DATAFILE BULLETIN

BULLETIN NO: 1085-1

Equipment: 132—174 MC MASTR Progress Line Receivers

Symptom: AUDIO HOWLING

Fig. 1 - Old Circuit

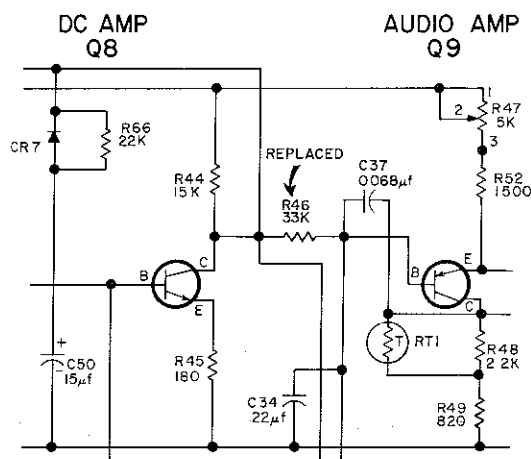
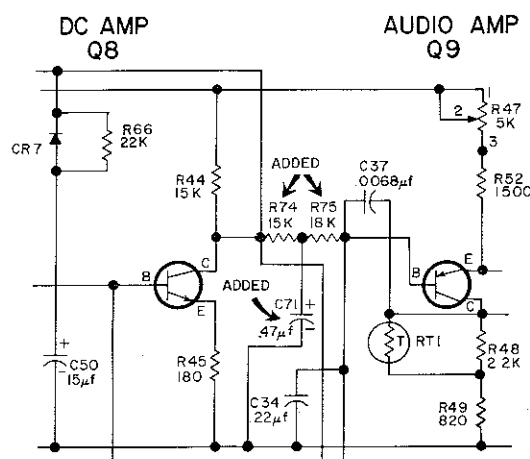
This revision provided decoupling between the output of the DC amplifier and the input of the first audio stage to reduce rumble at low volume settings. Resistor R46 was replaced by decoupling network R74-R75-C71 on the IF/Audio & Squelch Board.

Field Solution: If rumble is noticed at low volume settings, it can be eliminated by adding the decoupling network on the IF/Audio & Squelch Board as follows

1. Remove R46 (33K ohms $\pm 10\%$, 1/2 watt) from the IF/Audio Board.
2. Mount R74 (15K ohms $\pm 10\%$, 1/2 watt) and R75 (18K ohms $\pm 10\%$, 1/2 watt) in the holes from which R46 was removed. See Figure 3.

Fig. 2 - New Single-Unit Filter

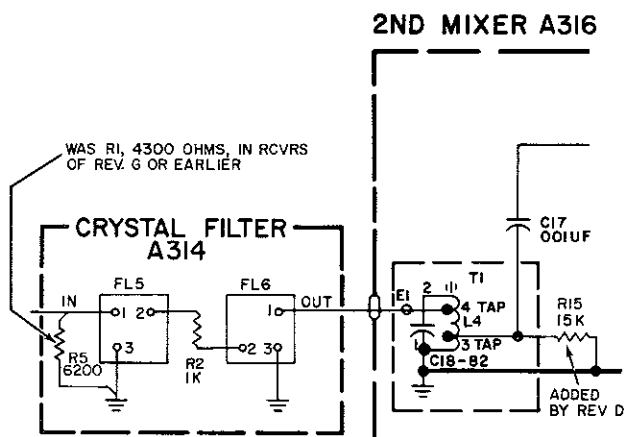
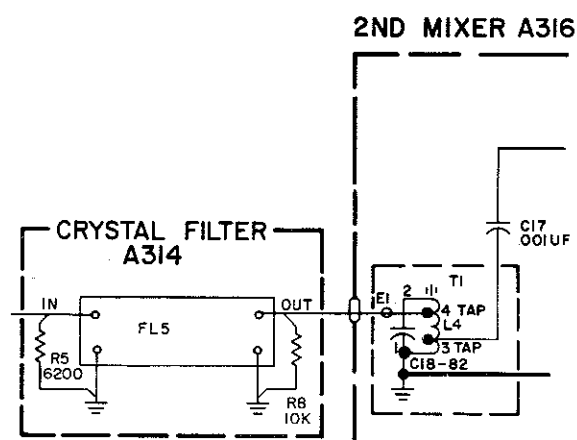
This revision replaced Hi-IF crystal filters FL5 and FL6 (GE Part No. 19B304094-G4) with single-unit filter 19B206692-G1 to improve selectivity and simplify manufacturing. The old and new filters are shown in Figures 1 and 2. Note that the filter-loading resistors were also changed, and R15 was deleted on 2nd Mixer Board A316.

This revision will not normally be made in the field unless filter FL5 or FL6 fails. It will then be necessary to replace both filters with the new single-unit filter:

1. Remove FL5 and FL6 with their loading resistors. Mounting screws for the filters are accessible by removing the Multiplier Selectivity.

Figure 3 - Installation of New Single-Unit Crystal Filter

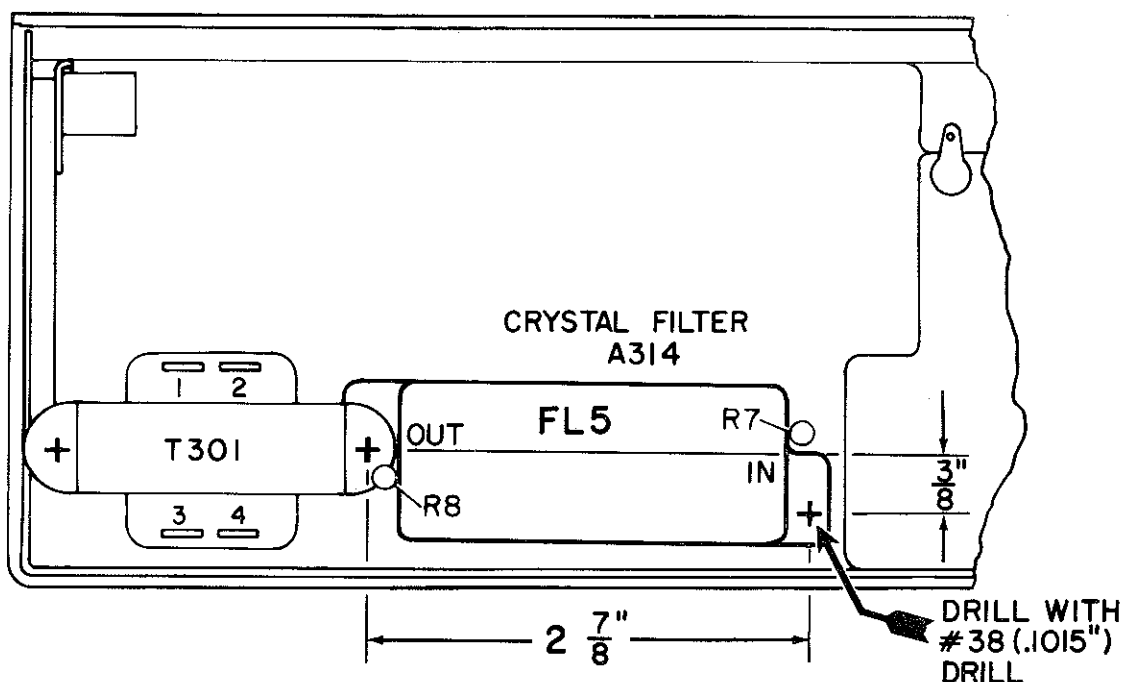
2. Connect R5 (6200 ohms $\pm 5\%$) across the input and R8 (10K ohms $\pm 10\%$) across the output of the new filter.
3. If a mounting hole is not already present, drill a hole for the new filter at the point indicated in Figure 3. Using a #4-40 x 1/4" self-tapping screw, mount one end of the filter at this point. Mount the other end under the mounting screw of T301.
4. Make the input and output connections to the filter.

Field Change: (cont'd) 5. On 2nd Mixer Board A316, clip out 15K-ohm resistor R15, if it is present.

Fig. 1 - Showing Diode Added

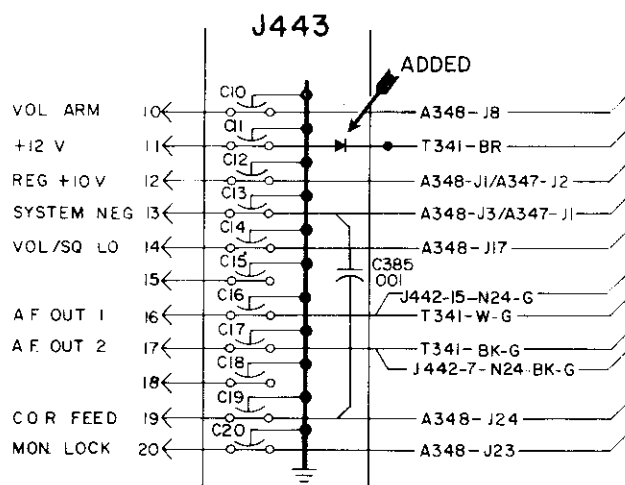
This revision added a diode in series with the +12 VDC supply lead to prevent negative spikes from reaching the output transistor. See Figure 1.

Field Solution: The diode should be added to receivers which do not have it, as shown in Figure 1. Connect the anode lead to J443-11 and the cathode lead to the brown wire from the audio output transformer. Use sleeving where necessary.

Fig. 2 - After Modification

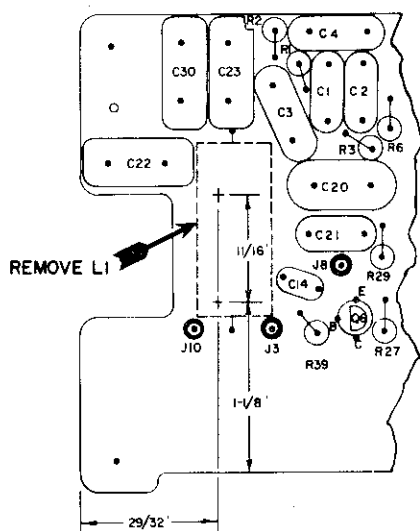
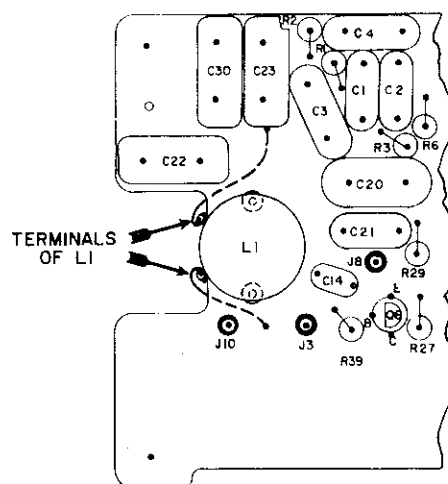
Factory Solution: Kit 19A122382-G4 is being added to all stations which use 2-watt receivers with Channel Guard. This kit replaces choke L1 of the tubular type (19A115690-P2) with a choke of pot-core construction (19B204554-G1).

1. Remove and discard the tubular choke L1 (19A115690-P2).
2. Drill two 1/8" holes in the Channel Guard board at the locations shown in Figure 1.

3. Install eyelets in the two 1/8-inch holes.
4. Mount the new pot-core choke (19B204554-G1) in the eyelets so that the two terminals of the choke hang over the edge of the board. See Figure 2.
5. Using sleeved #22 bus wire, connect the choke terminals to the holes from which the old choke was removed.
6. Remove and discard the bracket used to fasten the back cover to the receiver. Otherwise, L1 will hit the bracket when the receiver is reassembled.
